**Monks Orchard  
Residents 'Association  
Planning**

<b>Reference:</b>	<b>24/02781/FUL</b>
<b>Application Received</b>	<b>Tue 13 Aug 2024</b>
<b>Application Validated</b>	<b>Tue 13 Aug 2024</b>
<b>Address:</b>	<b>27 Orchard Rise Croydon CR0 7QZ</b>
<b>Proposal:</b>	<b>Demolition of existing dwellings and the construction of 4 semi-detached dwellings with associated parking, refuse &amp; cycle storage.</b>
<b>Status:</b>	<b>Awaiting decision</b>
<b>Case Officer:</b>	<b>Christopher Grace</b>
<b>Consultation Date:</b>	<b>8<sup>th</sup> September 2024</b>
<b>Decision Deadline:</b>	<b>Tue 08 Oct 2024</b>

Please accept this letter as a formal objection to Application **Ref: 24/02781/FUL** for **Demolition of existing dwellings and the construction of 4no. semi-detached dwellings with associated parking, refuse and cycle storage, at 27 Orchard Rise, Croydon CR0 7QZ.**

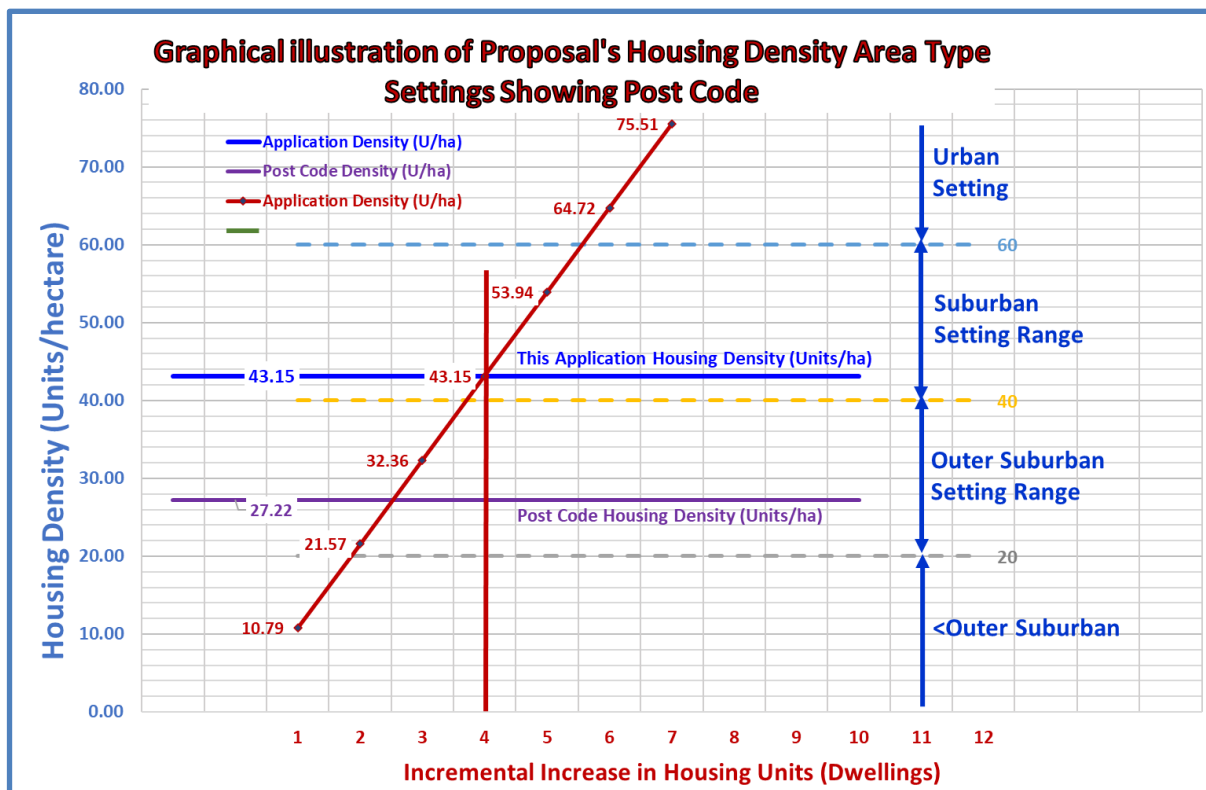
The Post Code (CR0 7QZ) has a 'Housing Density' of **≈27.22Unit/ha** and a 'Residential Density' of **≈66.44 Persons/ha**. These assessments place the Current Post Code 'Design Code' Housing Density for the locality of the proposed development at **27.22Units/hectare** which is within an "**Outer [London] Suburban**" Area Type; and Residential Density at **172.60 bedspaces/ha** which is bridging a 'Suburban Area Type to an 'Urban' Area Type setting, as defined by the National Model Design Code & Guidance (NMDC&G).

The Application 'Design Code' need comparing with the Post Code Design Code for acceptability. It is appropriate to compare the Application with those of the locality defined Post Code 'Design Codes' as provided in the National Model Design Code referenced from the NPPF (2023) at para 134.

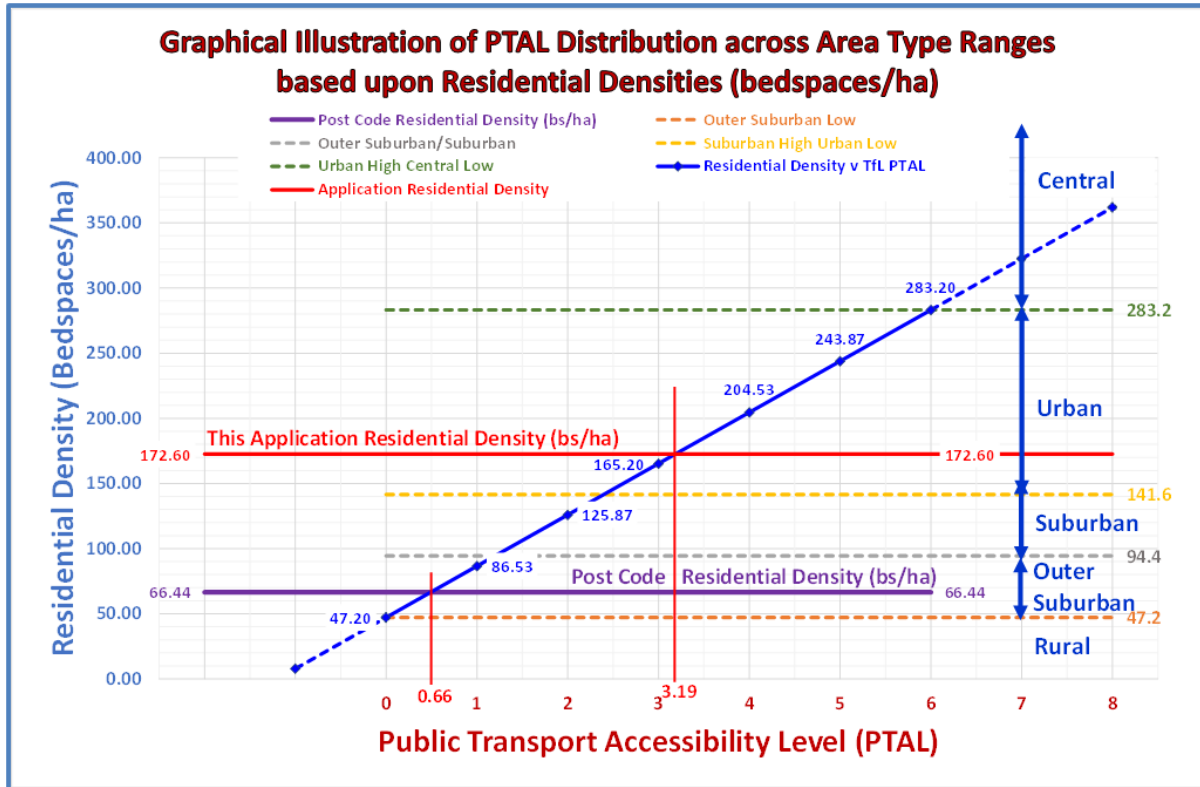
The assessment **clearly indicates** that the proposal exceeds the local **Post Code Area Type** by **58.52%** which would require **bridging** the established **Area Type** from **'Outer [London] Suburban'** to **'Suburban'** with **no planned increase in supporting infrastructure**.

The equivalent assessment of **Residential Density** based upon the **National Average Occupancy** <sup>6</sup> of **2.36 Persons/Dwelling** (2023), would be an increase of **159%** from an **'Outer [London] Suburban'** Area Type, which is **bridging** the **"Suburban"** Area Type and into an **'Urban'** Area Type again without any **proposed increase in local Infrastructure**, especially considering the **Residential Accessibility to Public Transport** which is currently **PTAL 1a** (≡ 0.66). This is conclusive proof of **over development for the locality**.

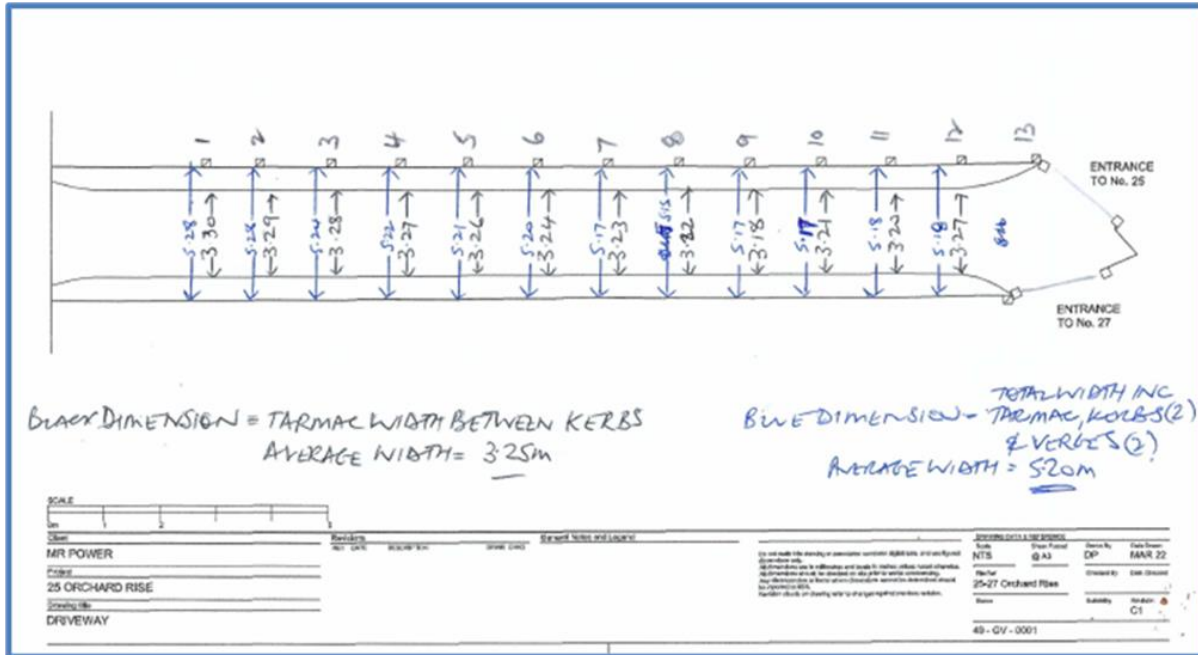
It is our considered view that the shared **driveway Access** is **inadequate** for the number of additional disproportionate **Pedestrians (16)** and **(Car 5)** regular **vehicular** traffic movements by **occupants and visitors which will cause disproportionate wear and tear.**

**The Driveway does NOT meet Public Realm design requirements.**

The **Access Drive** has minimum width of **3.18m** (pinch point) over the **tarmacked** surface and an average **width** over the full 'length' of **3.25m.** The overall width, including the grass verges either side has a minimum width of **5.15m** and average

width over the full 'length' of **5.2m**. The drive is **42.55metres** plus a crossover ramp of **4.60metres**; and thus, the overall length of drive from site boundary to road is **47.15metres**.

**Thus, the 3.7m width depicted in the Drawing N° ORCHRD-ZZ-04-DR-A-01 302-A3 Date 29-05-2024 is unreliable and misleading.**

**MORA's assessment of Drive Access requirements.**

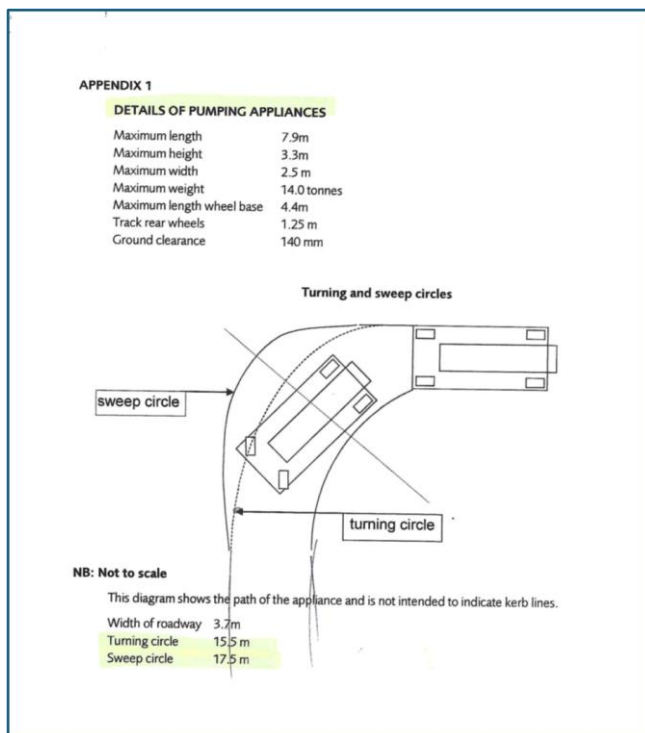
In order to access the Driveway from Orchard Rise, a Fire Appliance would require an inner (Nearside) turning radius of **≥5.66m** and an outer (offside) radius of **≤10.18m** (See illustration) which is insufficient as the vehicle specifications require the swept path radius is limited to **equal to** or greater than **≥17.5m**. which presumably also requires a safe clearance tolerance added either side.

As the Fire Appliance vehicle has forward and rear bodywork overhang of the wheelbase, the turning radius needs to compensate for the full sweep of the vehicle perimeter, front & rear, nearside and offside, to miss the adjacent Street Tree.

Therefore, we conclude Access is **NOT physically possible** and that the **fire appliance vehicle could not feasibly access the driveway.**

**Figure 4.6 Example code for rear building line projection of dwellings in a semi-detached character type (such as Metroland Estate)**

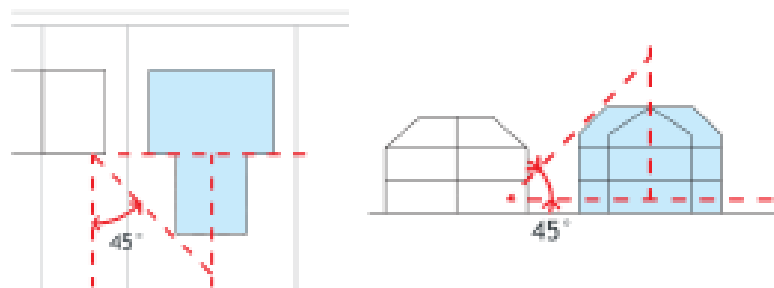
The 45° Degree projection from the Flank Wall window of 25 Orchard Rise would intersect the corner of the proposed development by a significant amount which fails to meet the London Plan SPG – Small Site Design Code para 4.5 recommended guidance.
